Access Compliance Report

Public Rights-of-Way

(Curb Ramps)

Intersection ID: 22038	Main Street: DELPOND_LN	Cross Street: MIRABELL_RD	Location:	N
ADA ID: 1210F4269783	Ramp Type: PerpDiag	Initial Pass/Fail: Fail	Overall Compliance: No	Severity Score: 21.25
Codes/Mitigation Info/Possible Solution		Field Measurements/Component Compliance

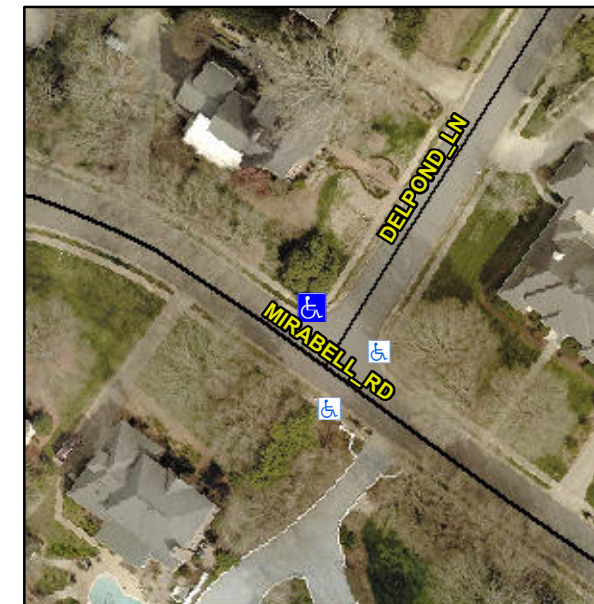
Not Found, R304.5.1, R304.5.3

Compliance	Description	Data	Compliance	Description	Data
N/A	Ramp Length (in)	47.5	Yes	Ramp Slope (%)	7.4
No	Ramp Width (in)	40.0	No	Ramp XSlope (%)	6.4
N/A	Flare Type LT	N/A	N/A	Flare Type RT	N/A
N/A	Flare Slope LT (%)	N/A	N/A	Flare Slope RT (%)	N/A
N/A	Flare Traversable LT?	N/A	N/A	Flare Traversable RT?	N/A
N/A	Landing Length (in)	N/A	N/A	DWS Provided?	N/A
N/A	Landing Width (in)	N/A	N/A	DWS Contrast?	N/A
N/A	Landing Slope (%)	N/A	N/A	DWS Length (in)	N/A
N/A	Landing X Slope (%)	N/A	N/A	DWS Full Width?	N/A
N/A	Landing Curb? (Y/N)	N/A	N/A	DWS Offset (in)	N/A
N/A	Shared Landing?	N/A			
N/A	Gutter Ponding?	N/A	N/A	Gutter Slope (%)	N/A
N/A	Gutter Lip Ht (in)	N/A	N/A	Gutter X Slope (%)	N/A
N/A	Painted X Walk1?	No	N/A	Painted X Walk2?	No
	X Walk 1 Direction	To SW		X Walk 2 Direction	To SE
N/A	X Walk 1 Width (in)	N/A	N/A	X Walk 2 Width (in)	N/A
	X Walk 1 Slope (%)	1.9		X Walk 2 Slope (%)	2.9
	X Walk 1 X Slope (%)	0.3		X Walk 2 X Slope (%)	7.0

Remove & Replace Curb Ramp With Two New Directional Ramps or Equivalent.
